MN/GK
15040
2 September 2015

**S.75W MODIFICATION TO HUNTLEE MAJOR PROJECT APPROVALMP_10_0137
HUNTLEE NEW TOWN**

We write to you on behalf of Huntlee Pty Ltd requesting that the Department initiate amendments to Project Approval MP10_0137 pursuant to Section 75W and Clause 12 of Schedule 6A of the *Environmental Planning and Assessment Act 1979* (EP&A Act). Specifically the modification to the Stage 1 Project Approval seeks to amend the residential subdivision layout of sub-stages 3-5.

Figure 1 – Proposed location of sub-stages to be amended
Source: Roberts Day

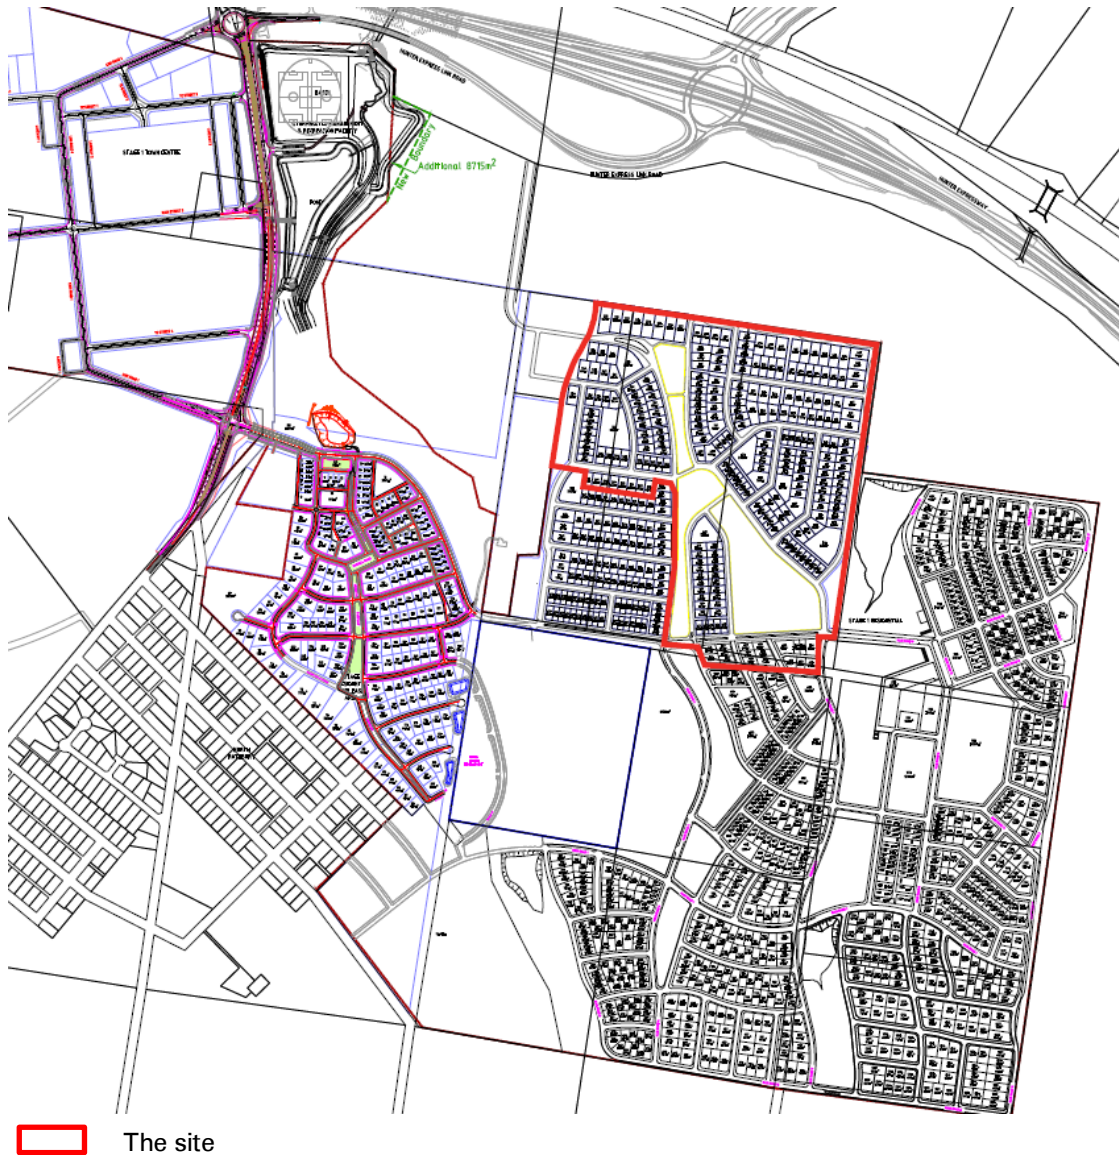
The modification seeks to make minor alterations to the residential lot layout within sub-stages 3-5. This land was the subject of Modification 3 to the Project Approval. The proposed modifications relate to the residential lot layout and access paths as well as the addition of a vehicular laneway. The proposed modifications are a result of the continual design improvement of Huntlee. The residential sub-stages 3-5 are identified below in **Figure 1**.

The proposed amendments to the lot layout generally comprise amendments to lot frontage widths to improve the street scape character and amenity of the allotments and are generally a consequential result of the amended pedestrian lanes. The proposed modifications to the lots, addition of a laneway and alignment of the pedestrian lanes are minor and do not result in any substantial changes to the subdivision pattern approved under Modification 3. Notwithstanding this, in order to commence the construction of the sub-stages, the amendments must form part of the Project Application approval prior to the issue of a Construction Certificate. The modified lot layout is shown in **Figure 2** below and a site wide Masterplan is provided at **Attachment A**.

Figure 2 – Passive surveillance view lines
Source: JBA

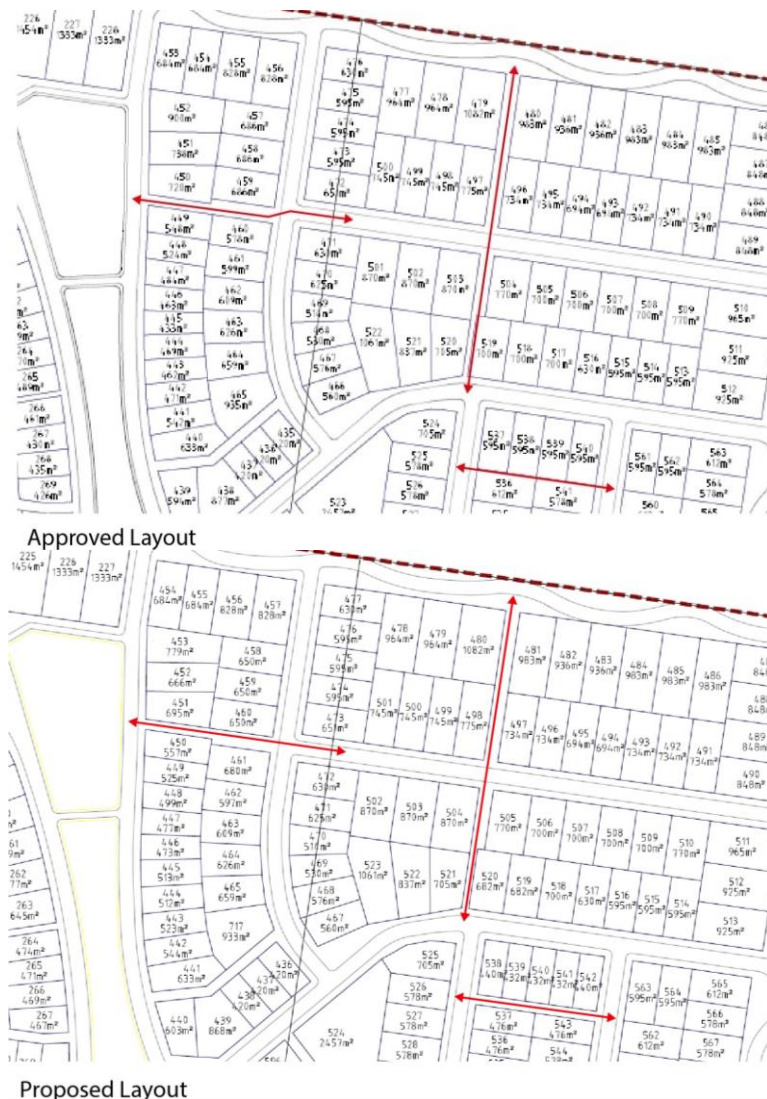
The proposed amendments to the subdivision layout are generally sub-sequential to the alterations to the pedestrian laneways. The addition of a vehicular laneway to lots 538-542 will improve circulation and access and will break up the street block. Two pedestrian laneways are amended to improve sight lines and encourage passive surveillance of streets and laneways. As shown in **Figure 2** below, the alterations to the laneways will better align with the adjoining local streets.
